Zoning Staff Report

Case Number: ZC-22-202

Zoning Map Amendment & Site Plan

PD SITE PLAN
Villages On Granbury
 33.080 Acres
 situated in the
CITY OF FORT WORTH, TARRANT COUNTY, TEXAS

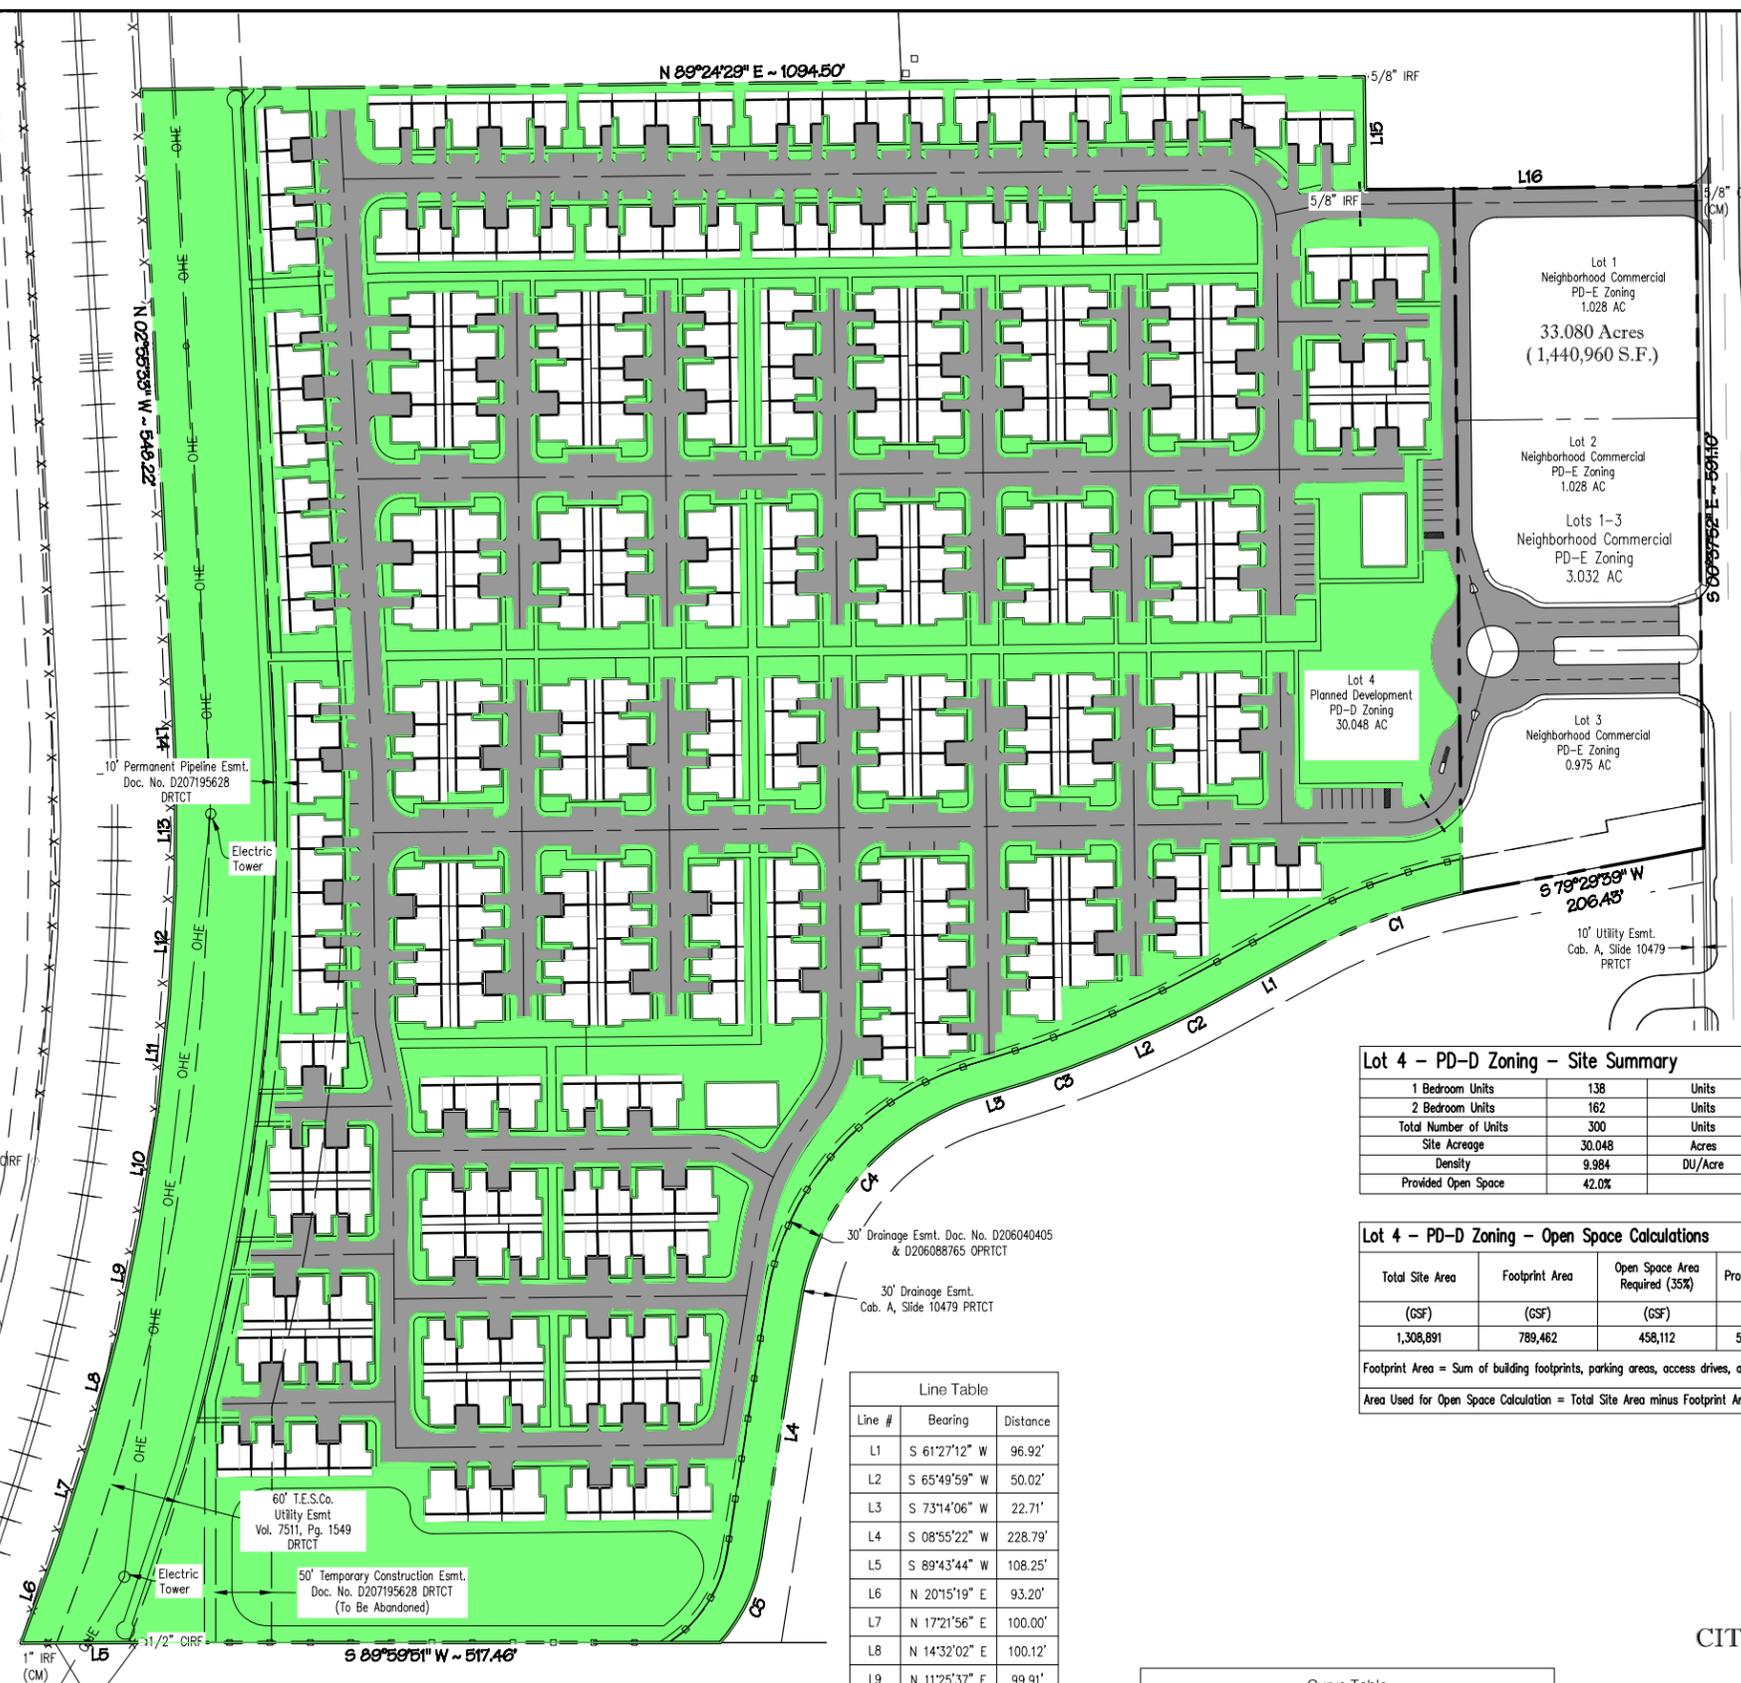
- On Site Plan, general notes 1 & 6 should reference "PD-E" not "E"
- Waiver Exhibit for PD-E section should have title section reading “Planned Development for all uses in "E" Neighborhood Commercial, with development standards (waivers) for building height, exclude the following uses: Tattoo Parlors, Pool Hall, No detached Pole Signs, Gas Lift Compressor Station, Gas Drilling & Production, Short Term Rentals; Site Plan Required”
- On Site Plan, label line or easement that cuts through detention pond

- FYI comment - verify all buildings are out of 10' permanent pipeline easement on western portion of site

Two approved points of access must be provided and streets/EAE must be constructed to fire access road standards. Where divided by a median, Fire Lanes are required to be a minimum of 20' wide on either side of the median. The minimum inside turning radius shall be 25', and the minimum outside radius shall be 51'.
IFC 2021/CFW Adopted Amendments Ordinance #25388-03-2022 Section 503.2

Vehicle gates required to be a minimum of 20' wide when fully opened and equipped with Knox Locks. Access Control Permits required for electric gates.

Fire lanes will need to be named for final platting.

Less than or equal 600 ft. (300 ft. radius) of space between hydrants along a direct horizontal line.

Less than or equal 500 ft. hose lay distance to all points of building.

FDC's for sprinkler and standpipe systems shall be located within 50 ft. of a dedicated street or fire apparatus access road and shall be within 150 ft. hose lay distance of the nearest fire hydrant. Each building shall be equipped with its own FDC, unless otherwise approved by the fire code official.

Water Demand and sewer loading are required. Submit request to WPD@fortworthtexas.gov

FYI: Site will require an accepted Drainage Study prior to Platting, IPRC Review, Grading Permit Issuance, Building Permit Issuance.

Site has FEMA SFHA; Flood Study may be required, and if required, acceptance is required prior to Floodplain Development Permit Issuance for Commercial Grading and IPRC Construction Activities.

A. (Subdivision Ordinance Ch. 31-101-c-1) Access: Multi-family developments of 100 dwelling units or more shall have a platted and constructed secondary ingress and egress to a public street. site plan only shows one point of ingress/egress.

B. Drive approaches on Granbury Road subject to access management policy. Will require interior access for commercial sites.

C. 6' sidewalk required along Granbury Road
